Technical Service Bulletin: tsb101518

New Fan Idler Dust Shields

This Service/Parts Topic announces a fan idler bearing dust shield, Part Number 3635105, for the QSK45 and QSK60 engines and updates Procedure 008-030, Fan Drive Idler Pulley Assembly.

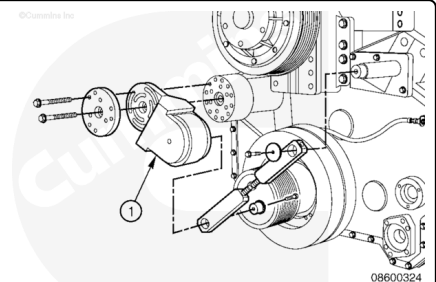
The new dust shields are installed on either side of the idler pulley as part of the Pivot Arm Assembly (1).

Note : When using dust shields with pivot arm assembly, Part Number 4066540, the use of the key shaft is not required. Fan idler bearings should be replaced with Part Number 4016800.

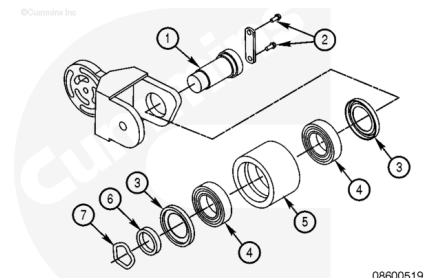
The bearings (4) mount on the idler shaft (1). The two dust shields (3), packed with grease, mount to the bearings; one at the spacer (6) side, and the other at the shaft shoulder (1) side.
